#3037491-LU
3019 S Angeline St
Recommendation Phase
23 December 2021

ADDRESS		PROJECT INFO		PROJECT BRIEF	INDEX
3019 S Angeline St SDCI# 3037491-LU		Zoning Overlays	LR3(M1) / SF 5000 Columbia City Residential Urban Village Columbia City Light Rail Station Frequent Transit	The proposed project includes the removal of two existing portables and the construction of an apartment building containing approximately 89 Small Efficiency Dwelling Units (SEDUs). No parking provided.	Project Info / Project Brief 1
PROJECT TEAM					Urban Design Analysis 2-3
Owner	3019 S Angeline St, LLC	Lot Area	11,436 SF (LR3(M1)) 1,045 SF (SF 5000)		Existing Conditions:
Architect	SHW		12,481 SF Total		Survey 4
Surveyor	Terrane	Proposed Units	88		Site Photos 6-7
Arborist	Layton Tree Consulting	Vehicle Parking	None		Perspectives: Scheme C - Preferred 8
Community Outreach	Natalie Quick Consulting	Bicycle Parking	79 long term / 6 short term		Scheme Summary 9
					Priority Guidelines 10
					Guidance Summary 11

ALTERNATE: Angeline Switchback Ramp
(reviewed at 1st Land Use Planner meeting): MUP ITEM 3

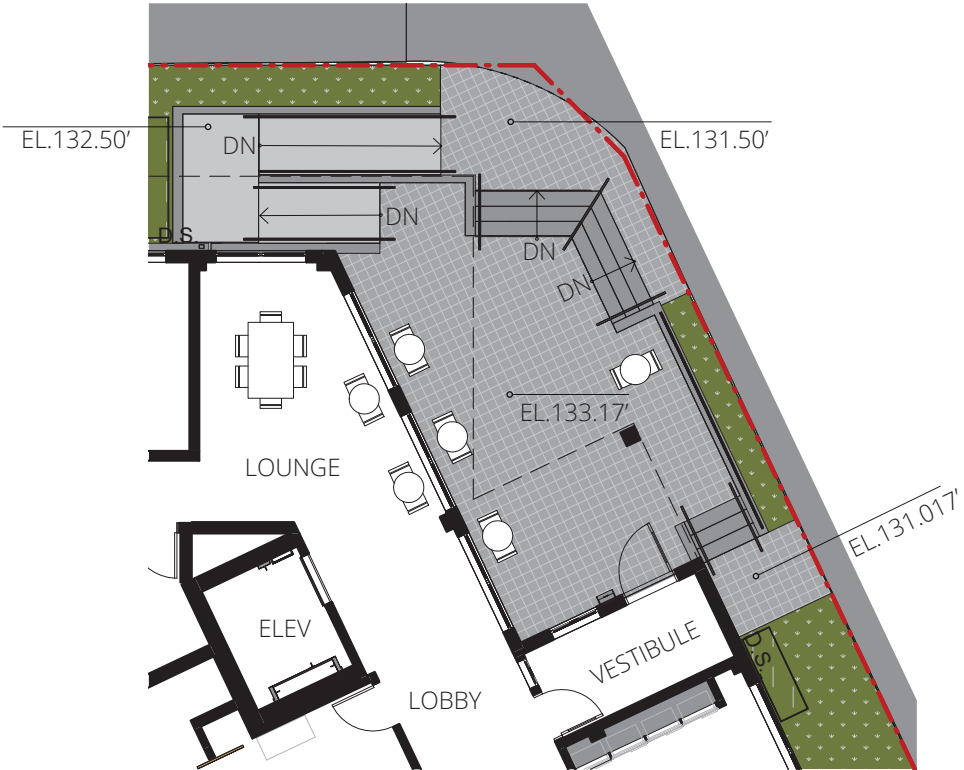
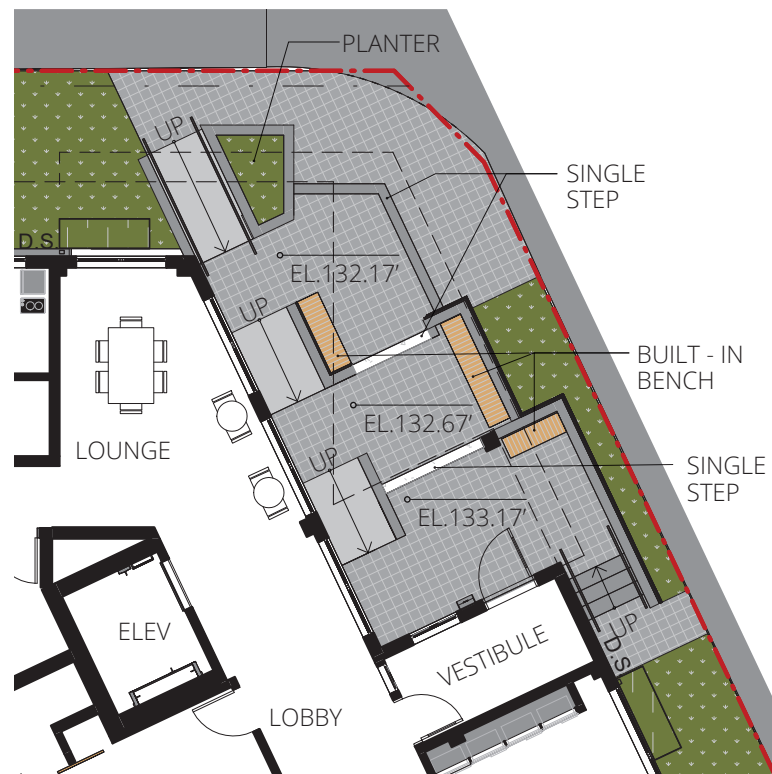
At EDG, staff supported the split massing with a void at the street corner that creates the primary entry but recommended further development of circulation & architectural elements to enhance wayfinding and usable space at patio.

This entry sequence was presented at the first planner meeting, in response to MUP correction #3, which requested further study of the entry circulation to increase the usable space at raised patio.

This entry sequence was not approved by land use reviewer, noting that the switchback ramp on Angeline created a barrier along Angeline. More study was requested.

The ramp was reconfigured to increase the usable space at the raised patio and create a connection to the interior lounge. This layout also provides covered seating. A stair was added for easy access for pedestrians entering from south on MLK Jr Way S.

ALTERNATE: Tiered Circulation
(reviewed at 2nd Land Use Planner meeting)

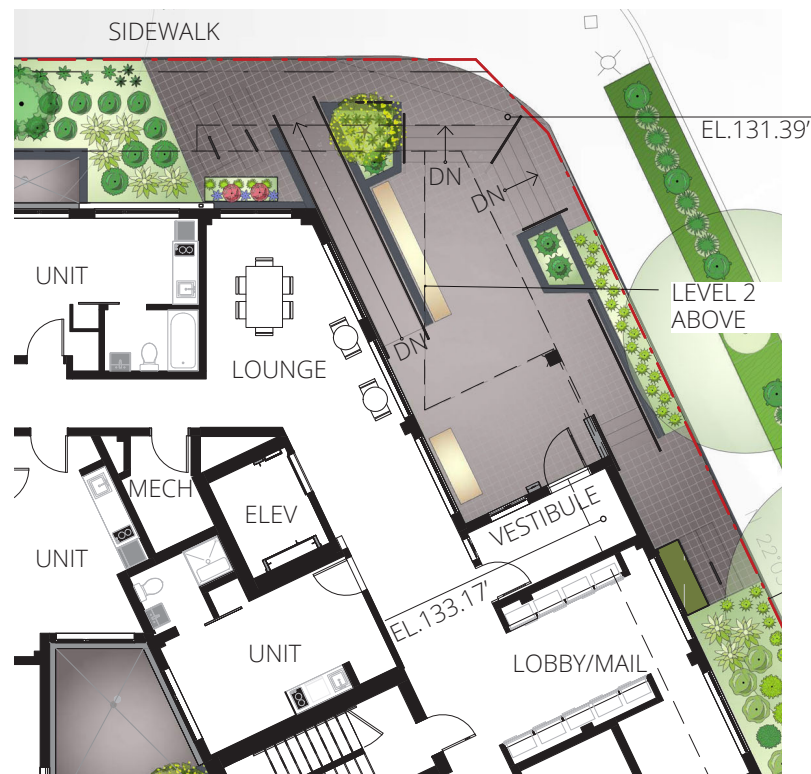
This entry sequence was not accepted by Land Use planner, noting it was too busy and lacked hierarchy.

The stairs and ramp were broken into tiers, creating greater connection and less division between patio and R.O.W. Built-in seating was worked into the tiers. Open railing was proposed to create visual connection.

Recommendation: Plan View Along S Angeline St

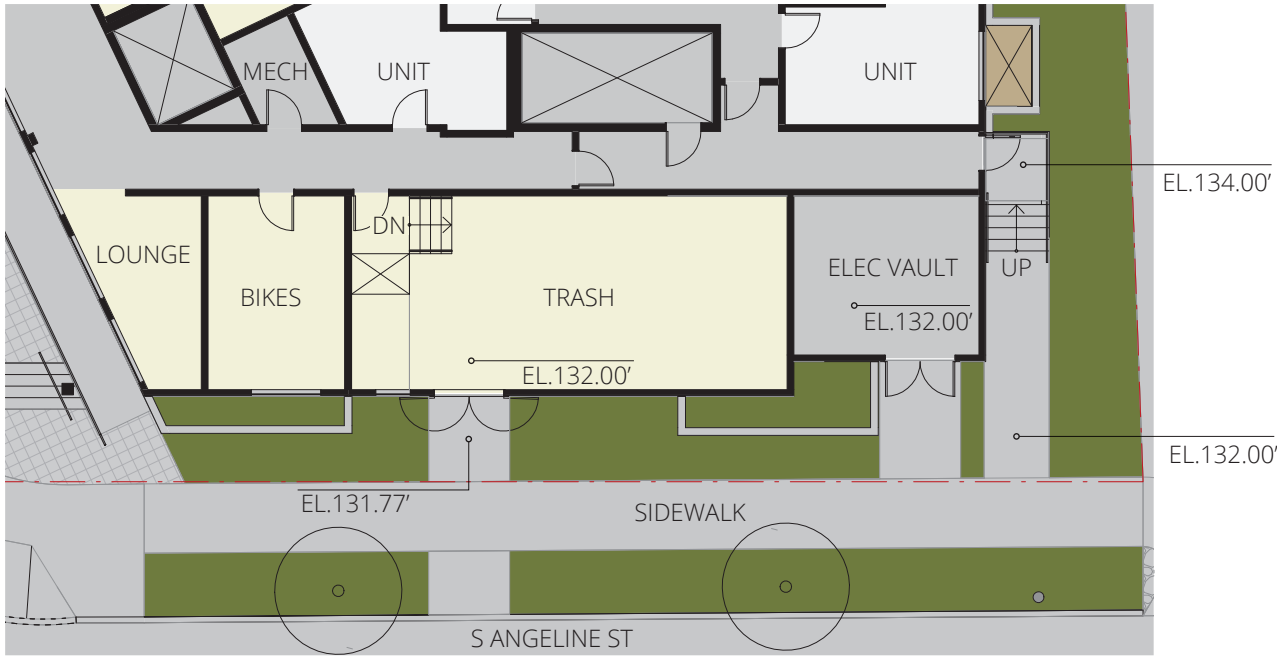
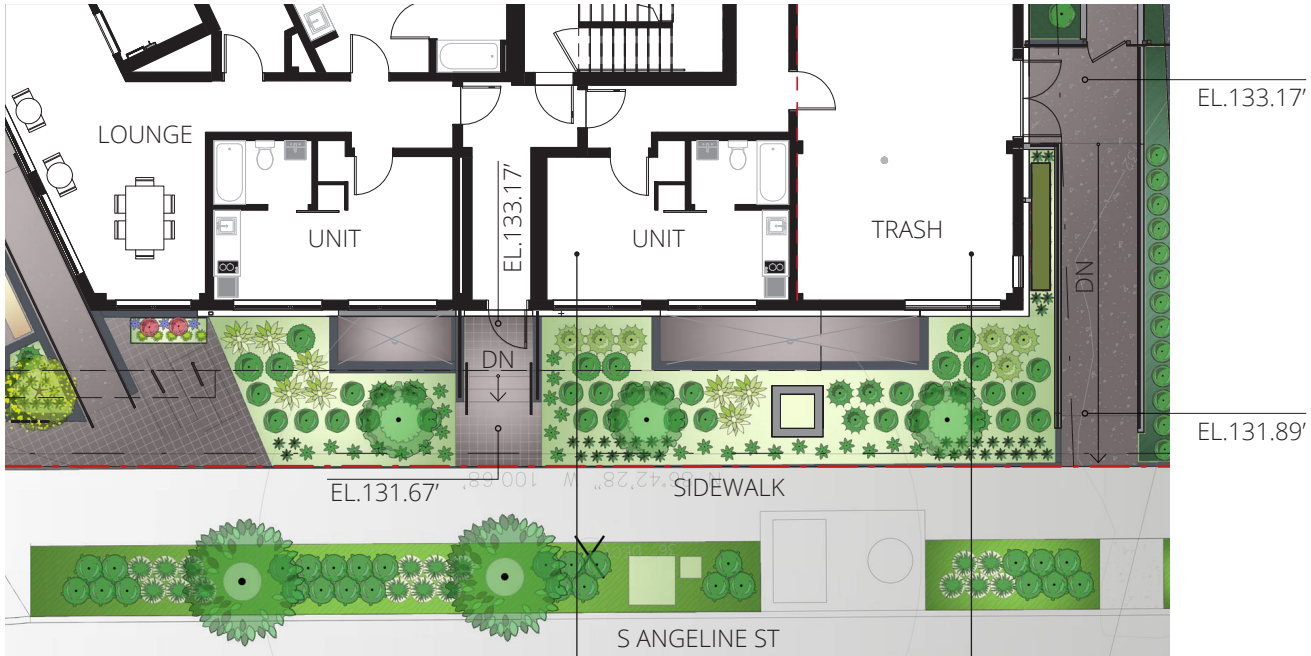
EDG Proposal & Guidance: 2a MUP ITEM 1

EDG and MUP guidance stated that the S Angeline St ground level frontage layout is not interactive or transparent, preventing activation along the sidewalk. This frontage should also begin to relate the building façade to the scale of the single family zone use to the west

To activate the Angeline street frontage, residential units were relocated to face S. Angeline St and the trash room and service door were relocated to the west. The additional openings were aligned with the exit door head to create a continuous datum and a balanced facade and reduce the blank wall. Landscape buffers the units, and the exit stairs and railing provide residential scale. See page 36 for Angeline St Level Development

Recommendation: Looking Southeast on S Angeline St

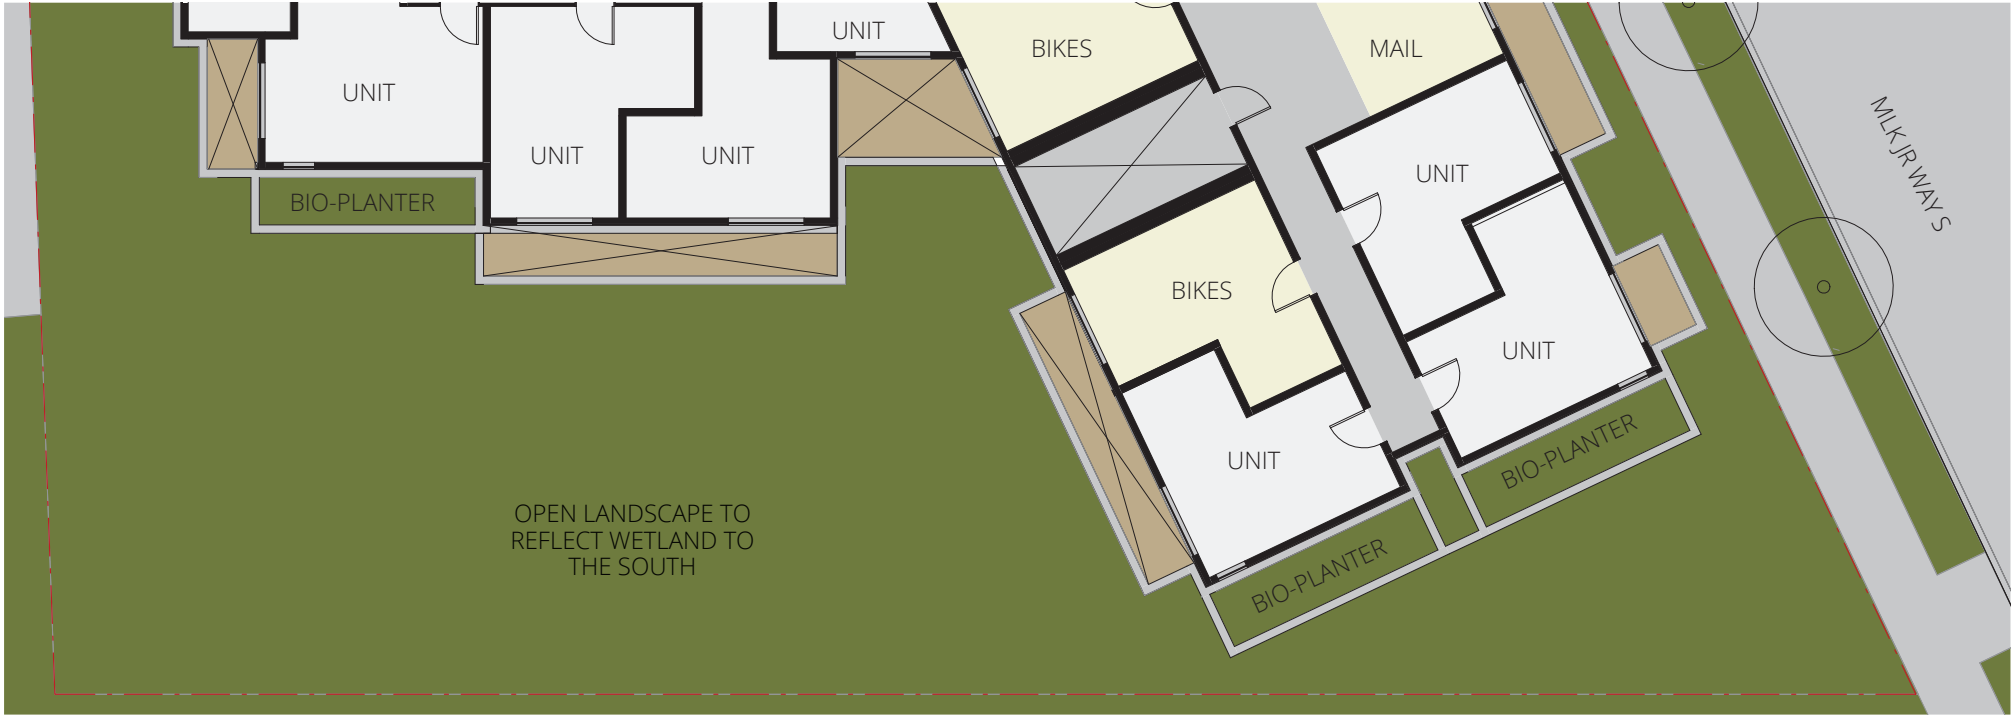
EDG Proposal & Guidance: ①a ①c ①d

Staff supports the stepped down massing along west edge, providing transition to the Single Family zone. Recommends study of the stepped modulation and how it relates to the other building massing and the Angeline facade.

The stepped massing facing the SFR zone was maintained and further refined. The lowered mass wraps the corner with level one pulled in to create continuity and an overhang.

Recommendation: Plan - Rear Yard

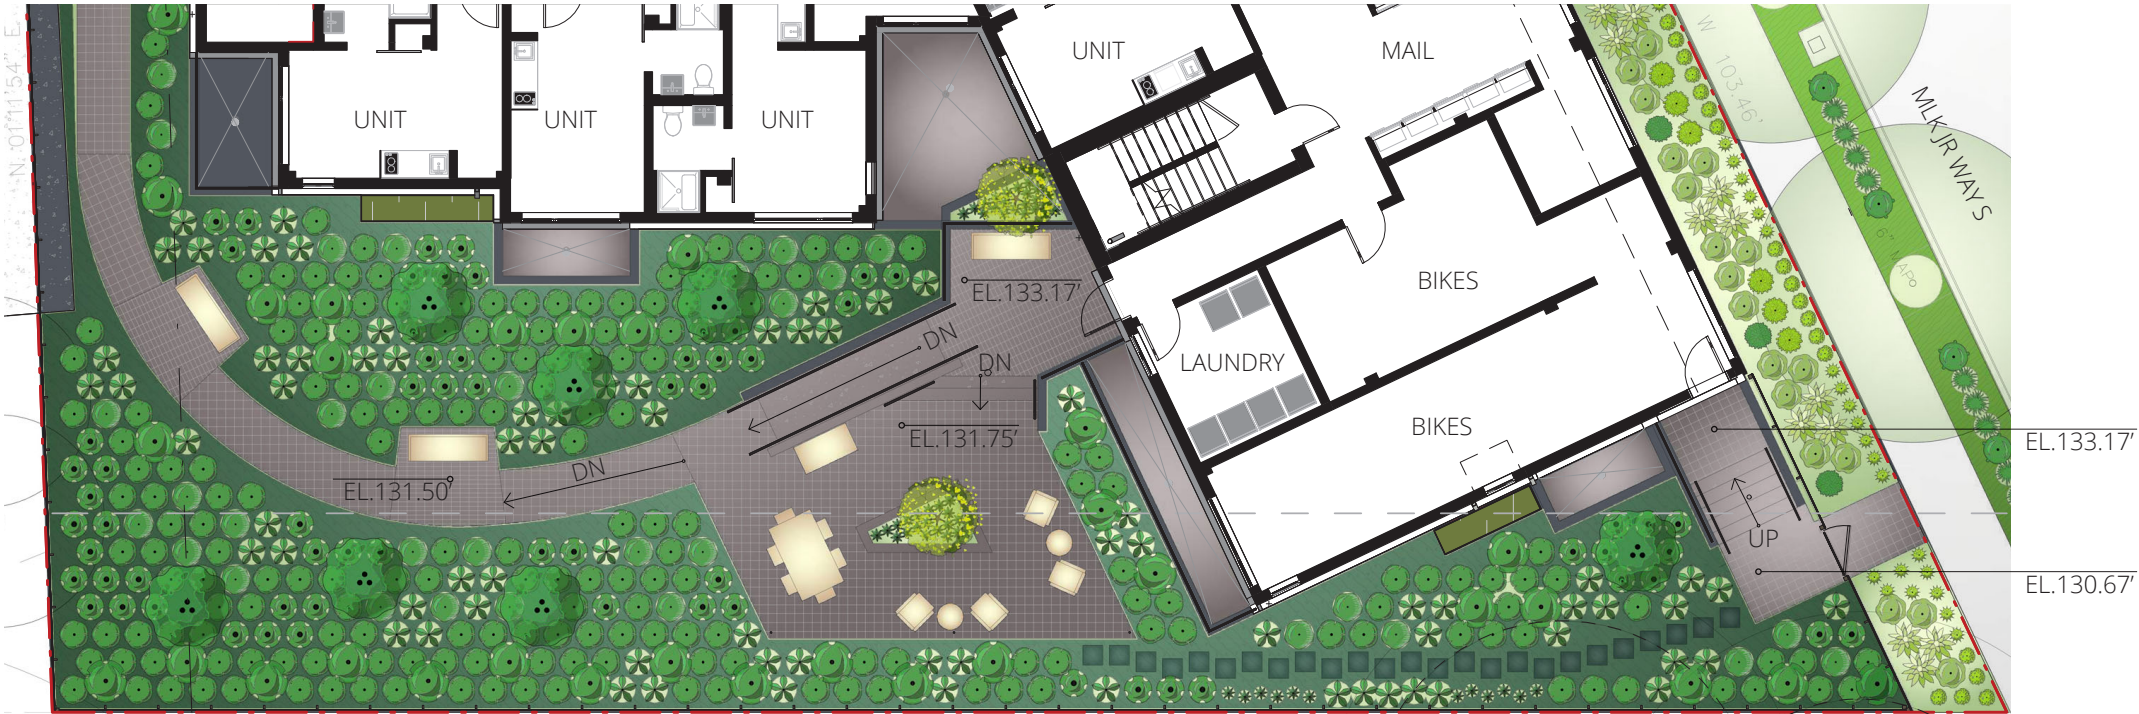
EDG Proposal & Guidance: ④b ④c MUP ITEM 4

Guidance recommended that the open space along the south property line should be developed to create usable outdoor space for the residents. A pedestrian connection to the outdoor space should be made from the main entry hall/lobby area to the deck to the outdoor space for easy access by the residents. Create visual transparency between interior and exterior use spaces for safety and activation.

While still maintaining much of the open yard space, a deck, at-grade patio and pathway seating was added as usable amenity to the rear yard. There is a direct accessible route from the lobby to the amenity space, with additional access paths from each street. The yard has been further enhanced with landscape, furniture and lighting (see p. 38 for Rear Yard Development).
